ENGINE - HP COMPRESSOR BLADES - INTRODUCTION OF REVISED LEFT HAND LOCK BLADES WITH
INCREASED PLATFORM CROP - CATEGORY CODE 6 - MOD.ENG-72-0284

V2500-ENG-72-0284

Rework of initial HP compressor LH lock blades
Fig.1

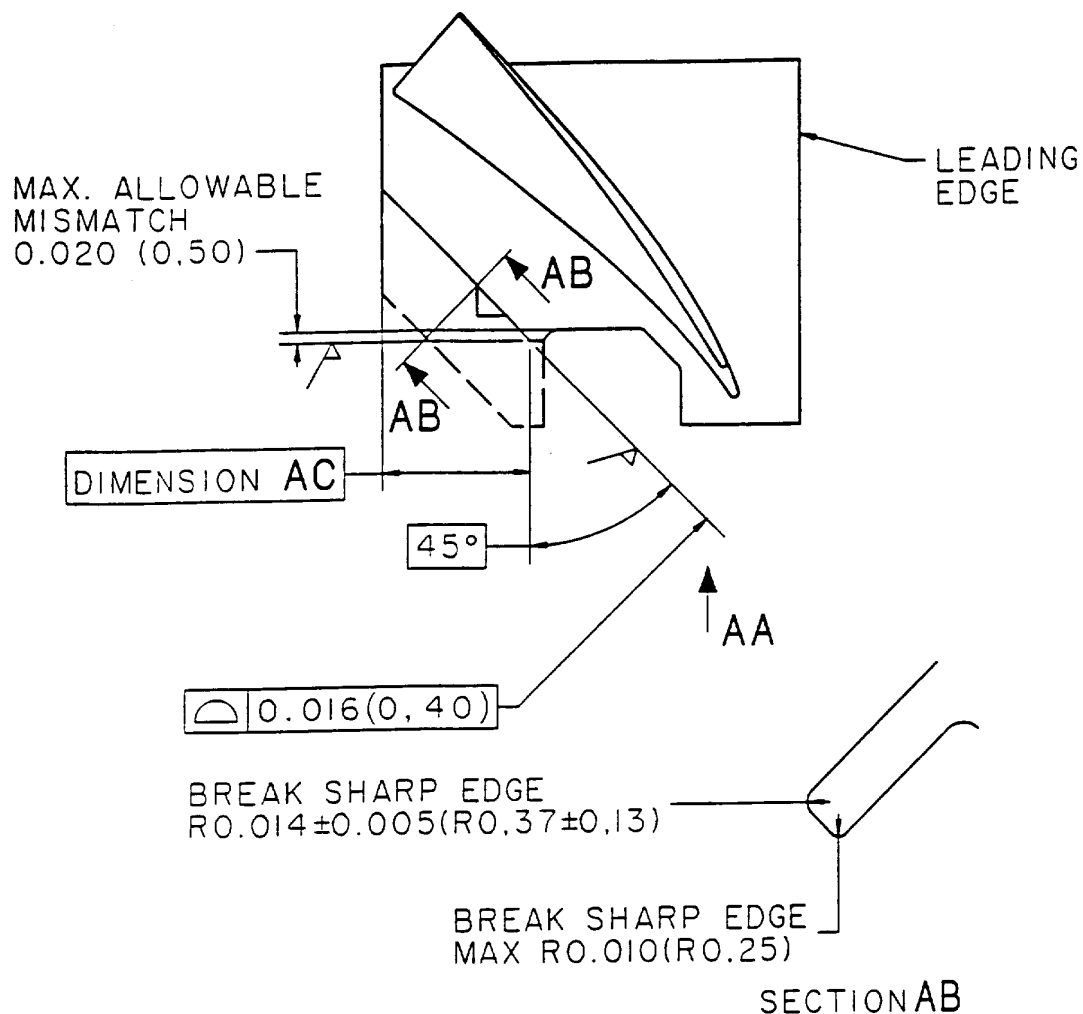
The platform of the left lock blades of the HP compressor can crack.

The problem is caused by excited platform vibration-modes which result in High Cycle Fatigue (HCF) cracks. The cracks start from the lock slot at the bottom of the platform overhang.

The left lock blades for stages 10, 11 and 12 have changed. To reduce the amount of overhang on the blade platform, the crop has been increased.

The left lock blades for stages 9, 10 and 11 have changed. To reduce the amount of overhang on the blade platform, the crop has been increased.

Stage 10, 11 and 12 left lock blades can be reworked, refer to Figures 1 and 2.

Stage 9, 10 and 11 left lock blades can be reworked, refer to Figures 1 and 2.

- | | | | | | | | | | |
|--|---|--------------|--------------|--------|--------|--------|--------|--------|--------|
| (e) Grind back the rotor blade platform, where shown | See Figure 2 and 3, as necessary,
Use a grinding machine | | | | | | | | |
| (f) Remove sharp edges | See Figure 2 and 3.
Use standard workshop equipment | | | | | | | | |
| (g) Etch the repaired area with cold ferric chloride | Refer to SPM TASK 70-11-39-300-503,
SUBTASK 70-11-39-300-001.
Use chemical cleaning equipment | | | | | | | | |
| (h) Do a local penetrant crack test on the repaired area | Refer to SPM TASK 70-23-05-230-501.
Use CoMat 06-022 fluorescent penetrant, with penetrant crack test equipment.
Cracks are not permitted | | | | | | | | |
| (i) Measure the dimensions | See Figures 2 and 3, as necessary | | | | | | | | |
| (j) Cancel the old part number and identify with the new part number |

ALL DIMENSIONS ARE IN INCHES (MILLIMETRES).
ANGULAR DIMENSIONS ARE IN DEGREES AND DECIMAL
PARTS OF A DEGREE.
MACHINE SURFACE FINISH TO BE 125 MICROINCHES
(3.2 MICROMETRES) U.O.S.
MACHINE WHERE MARKED ✓
BREAK SHARP EDGES 0.012(0.30)±0.008(0.20) U.O.S.

LH lock blades - View on arrow AA
Fig.2

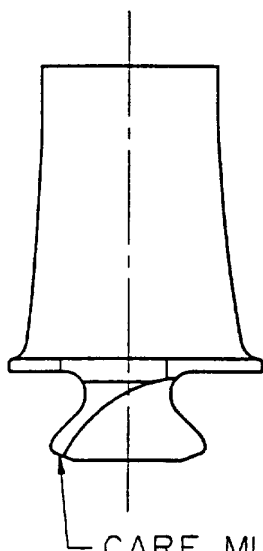
CARE MUST BE TAKEN TO ENSURE
THAT NO WITNESS OF PLATFORM
MACHINING APPEARS ON DOVETAIL

PART N°	DIM. AC
6A6563	0.2538 (6.448)
6A6564	0.2694 (6.845)
6A6565	0.2320 (5.895)
6A6566	0.2699 (6.857)
6A6567	0.2451 (6.227)
6A6568	0.2146 (5.453)
